STAFF REPORT: 03/12/2025 REGULAR MEETING PREPARE ADDRESS: 4071 LESLIE APPLICATION NO: HDC2025-00014 HISTORIC DISTRICT: RUSSELL WOODS-SULLIVAN APPLICANT/CONTRACTOR: ALEXANDER BELILOVESKY/ALEXANDRIA MANAGEMENT OWNER: DARIN BARNES DATE OF STAFF SITE VISIT: 2/25/2025 DATE OF PROVISIONALLY COMPLETE APPLICATION: 02/18/2025

## SCOPE: REPLACE STEEL CASEMENT WINDOWS

Google Streetview image from 2013. Note that the house appears much as it did at the time of the district's designation. Specifically, the awnings, foundation planting, and glass block windows at the front façade, flanking the front door, still remain

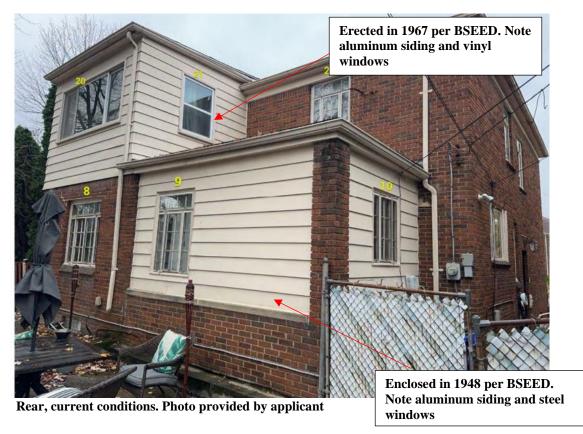
• Per the below images, the front façade glass block windows which flanked the front door, the awnings which were installed in 1967, and front yard foundation plantings were removed without HDC approval sometime between 2013 and 2018, by a previous owner

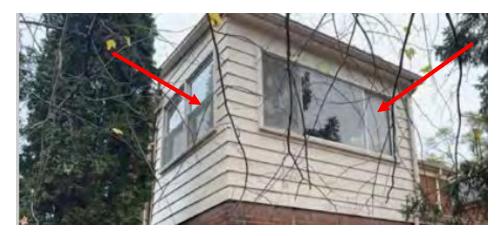
Google Streetview image from 2018. Note that the glass block windows that flanked the front door at the time of designation have now been replaced with fixed vinyl units. Also, the 1967 awnings have been removed and the foundation planting which were present at the time of designation are no longer present
